Access Compliance Report

Public Rights-of-Way

(Curb Ramps)

Intersection ID: 49385	Main Street: SOUTH_DEVON_ST	Cross Street: CHARBRAY_LN	Location: S
ADA ID: C4E44F696C6D	Ramp Type: PerpDiag	Initial Pass/Fail: Pass	Overall Compliance: No
Severity Score: 12.5			
Codes/Mitigation Info/Possible Solution		Field Measurements/Component Compliance

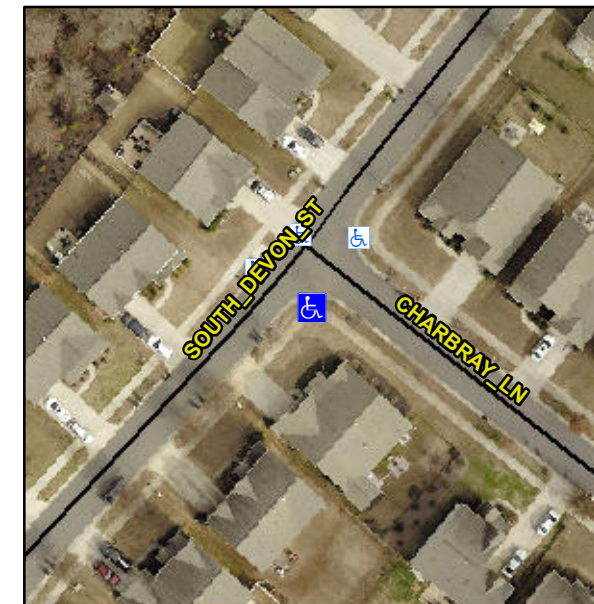
**Remove & Replace Landing.
Remove & Replace Gutter.**

**R304.2.2-Perp, R304.3.2-Para,
R302.7, R302.7.2, R304.5.4, R304.5.3**
